MOFFETT OFFICE PARK

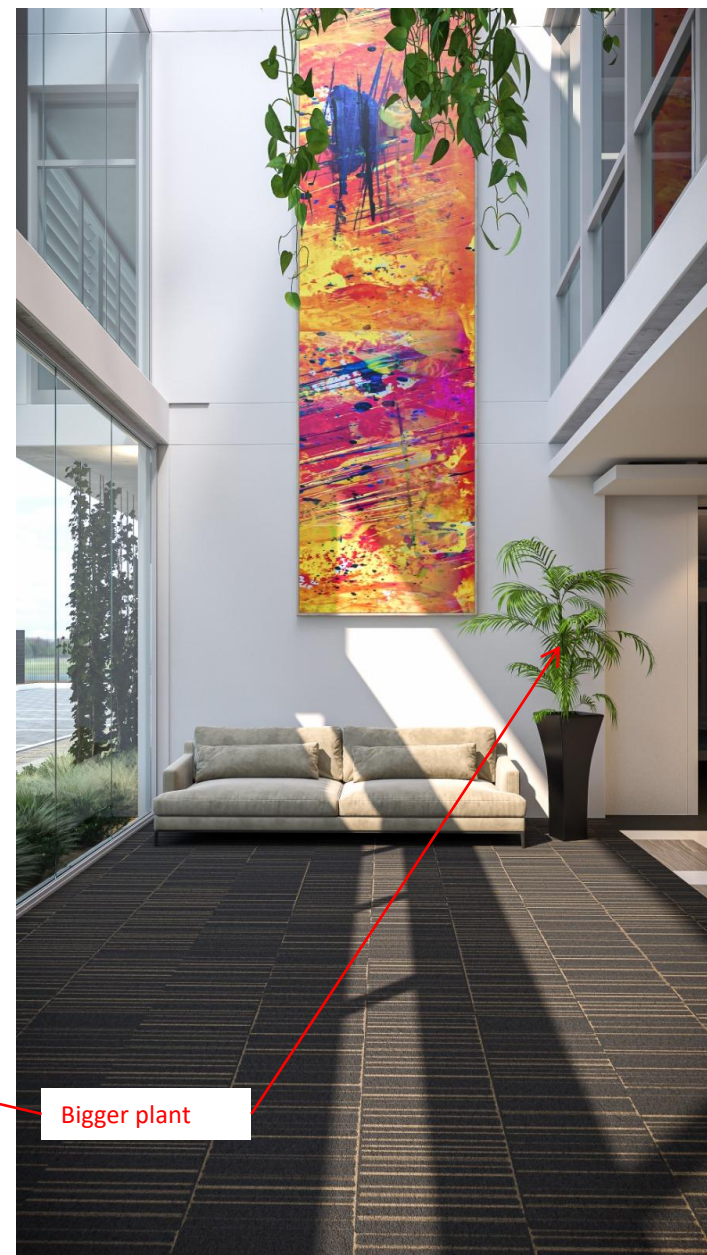
Populate with people.

Love this image!

Not sure about the artwork, although it does noit bother me.

Image brilliance to be adjusted so that walls are more defined without white-washing the sky

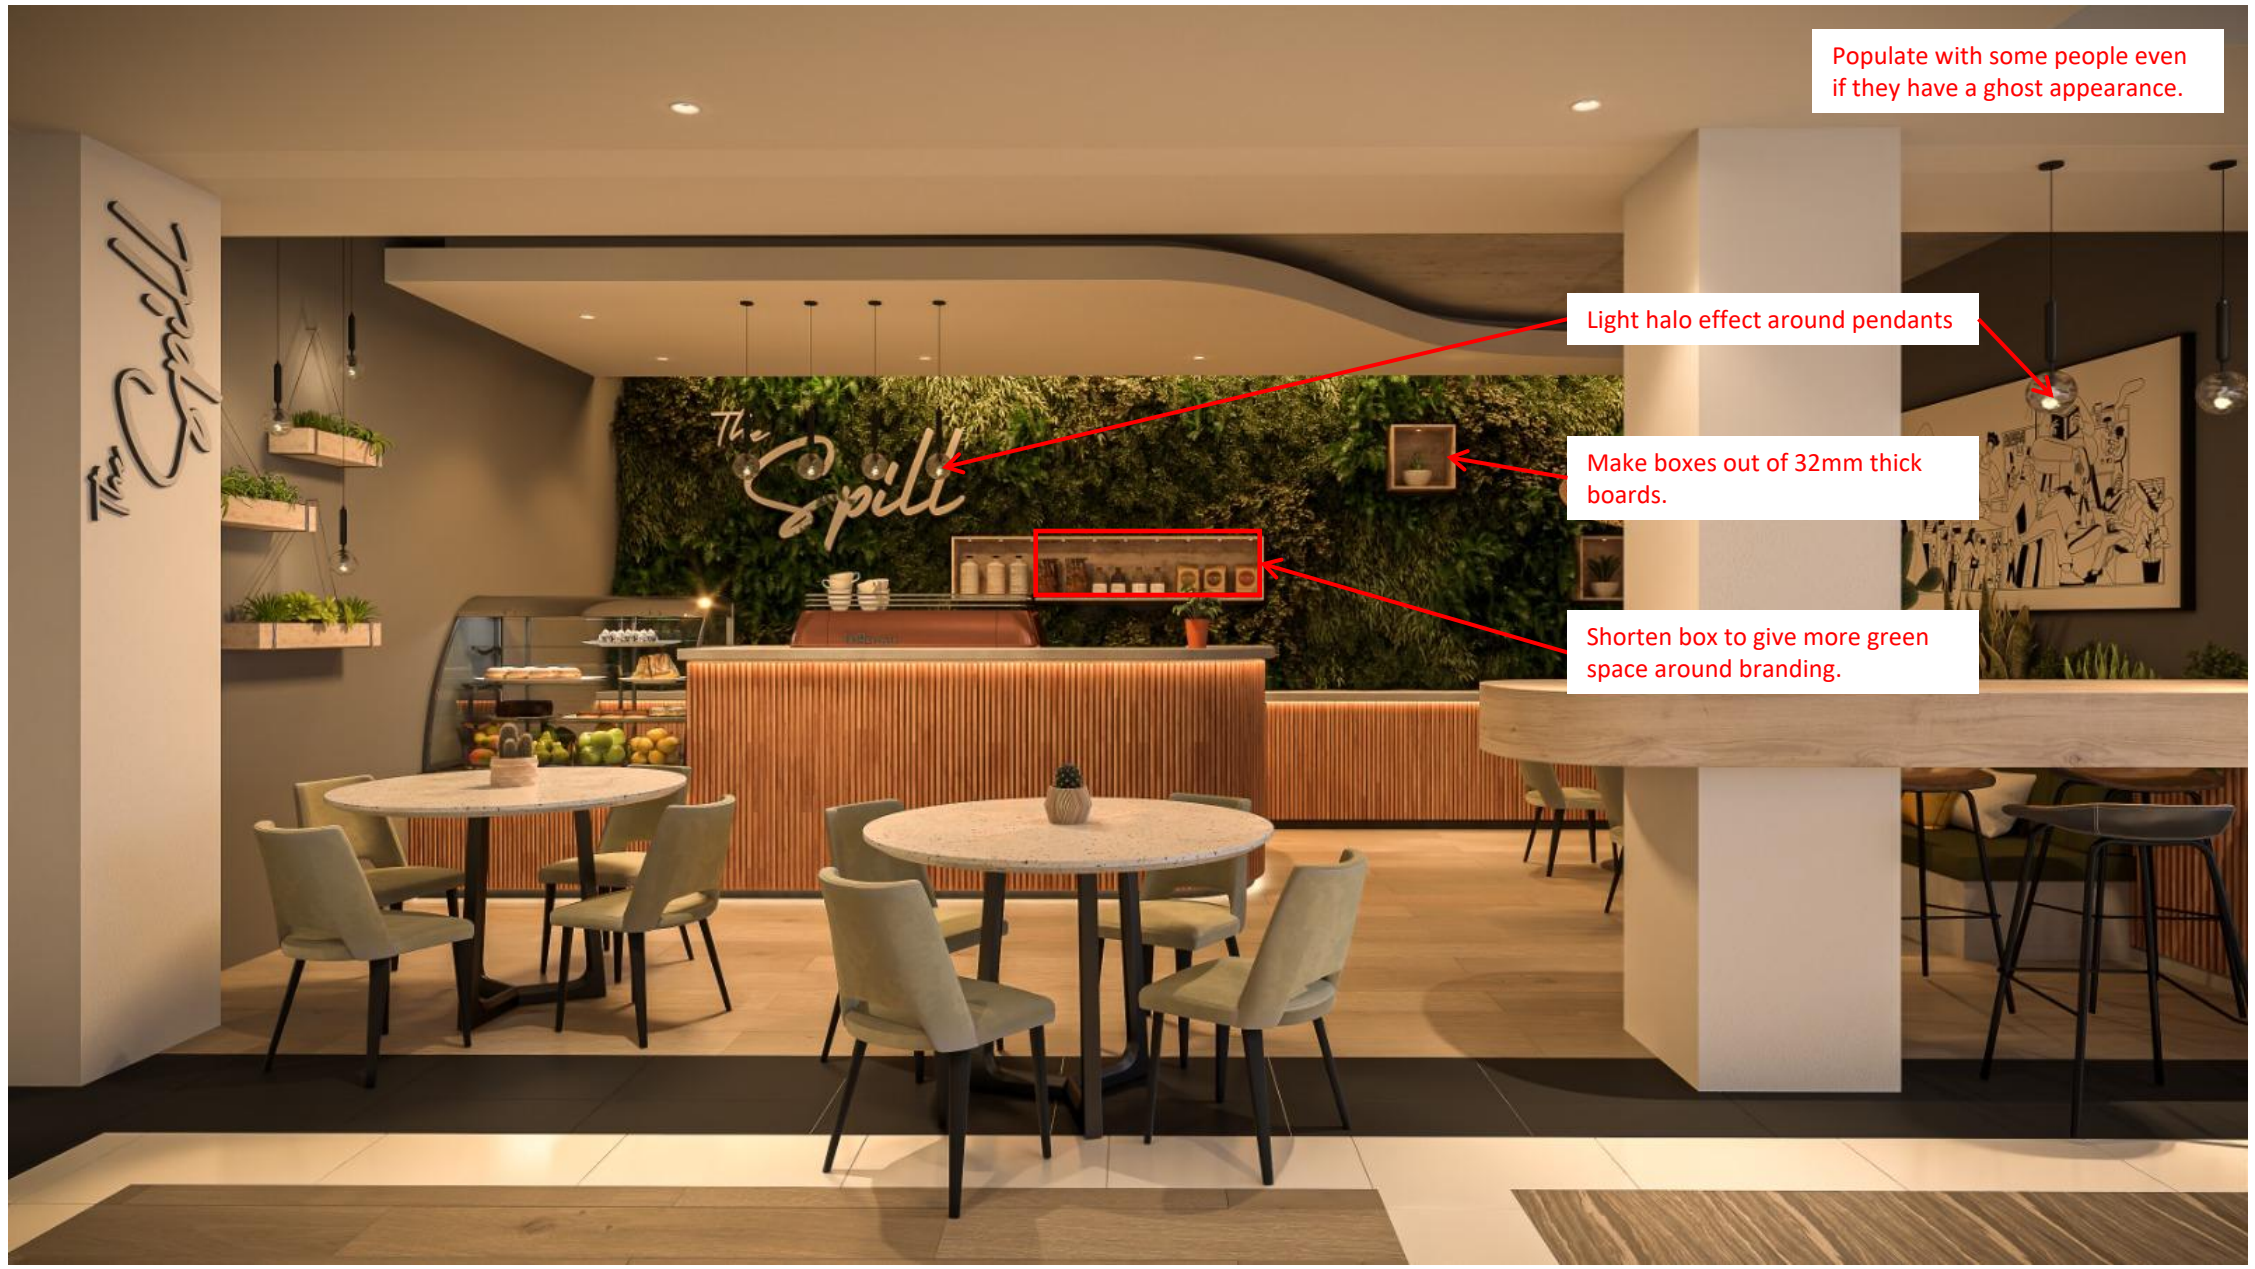
Love these images!

Not sure about the artwork, although it does noit bother me.

Play with shadows to try and get some direct sunlight on walls and floor.

Make image wider toward the exterior to try capture the free transformation between exterior and interior.

Populate with both static and blurred people.

Bigger plant

Populate with people

Slightly higher plants
and more dense.

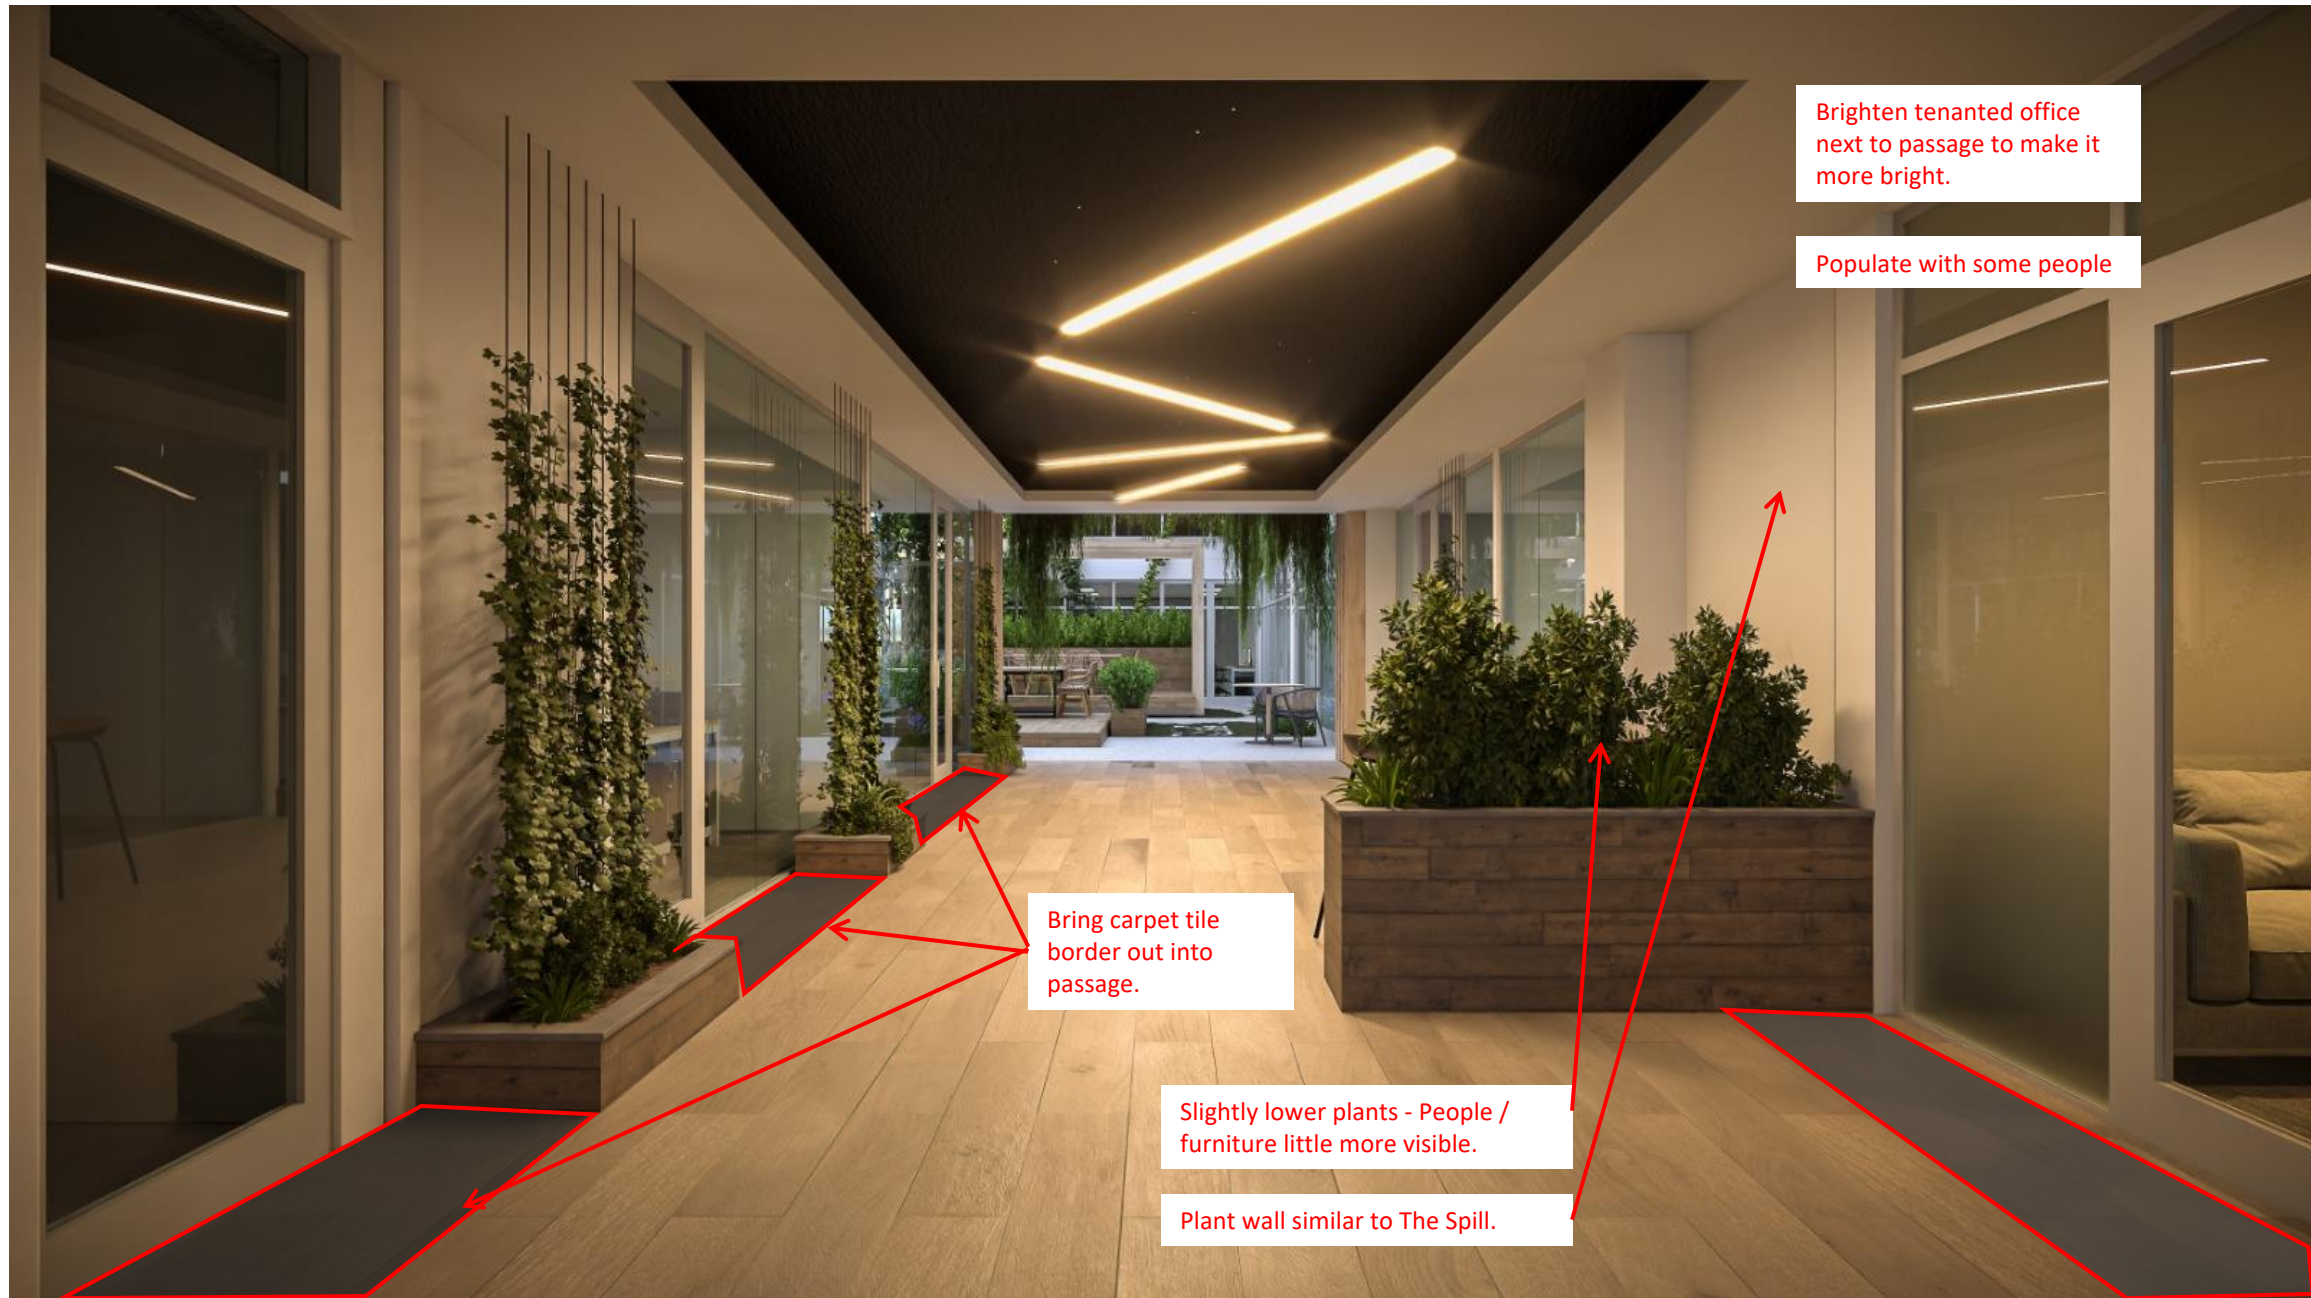
Slightly narrower chairs and shift across
so that they open the gap towards the
reception counter ever so slightly.

Populate with some people even if they have a ghost appearance.

Light halo effect around pendants

Make boxes out of 32mm thick boards.

Shorten box to give more green space around branding.

Make boxes out of 32mm thick boards.

Populate with some people even if they have a ghost appearance.

Light halo effect around pendants

Try to see if you can get the light to project the basket weaving pattern on the wall and table.

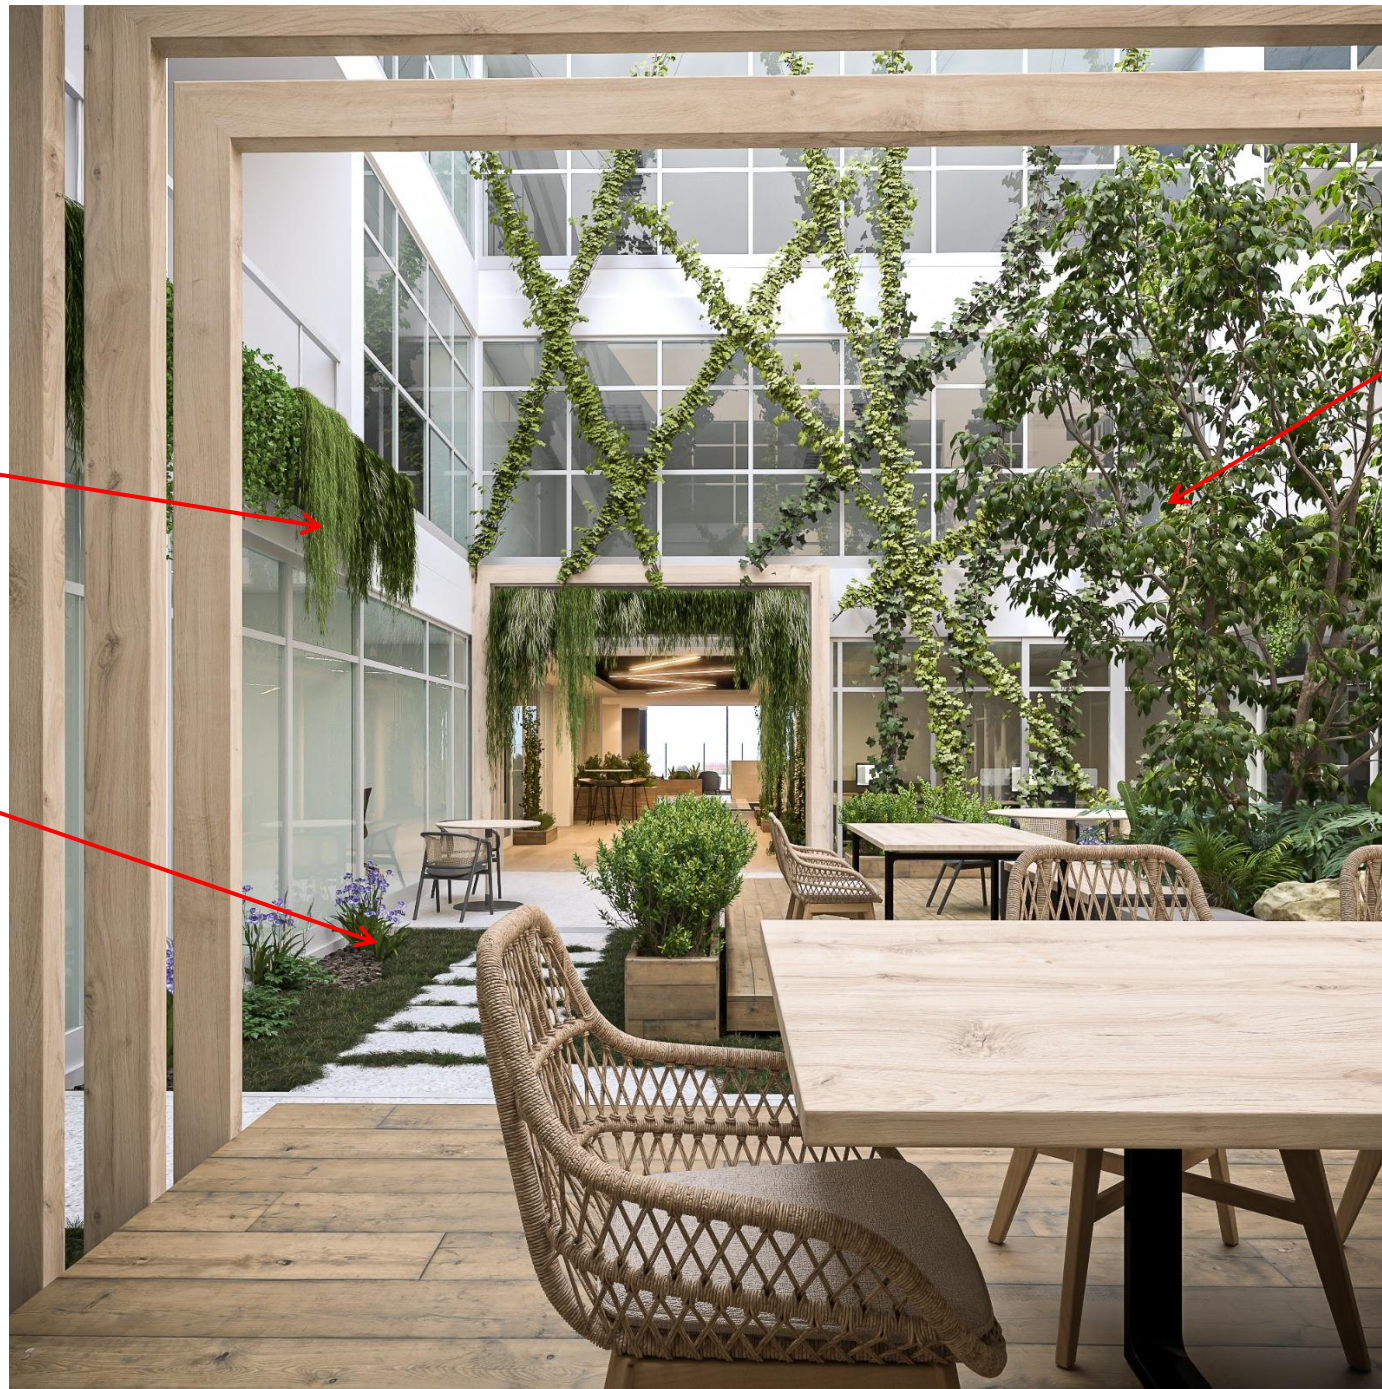
Brighten tenanted office
next to passage to make it
more bright.

Populate with some people

Bring carpet tile
border out into
passage.

Slightly lower plants - People /
furniture little more visible.

Plant wall similar to The Spill.

Populate with some people

Not crazy about the hanging plants from the first floor planters.

Like the idea but not the type of plant.

Love the general feel. Well done!

Add some of the same type of plants used at the main entrance for around the courtyard edges.

Ditto comments from previous image.

Ditto comments from previous image.

Populate with some people

Not crazy about the hanging
plants from the first floor planters.

Like the idea but not the type of
plant.

Add some of the same type of
plants used at the main entrance
for around the courtyard edges.

The tree looks a bit distressed -
Give it some water...;-)

The tree is just not cutting it.
Maybe lighter leafs??

Ditto on all previous comments.

Brilliance in mage needs to be
bumped without white washing
the sky.
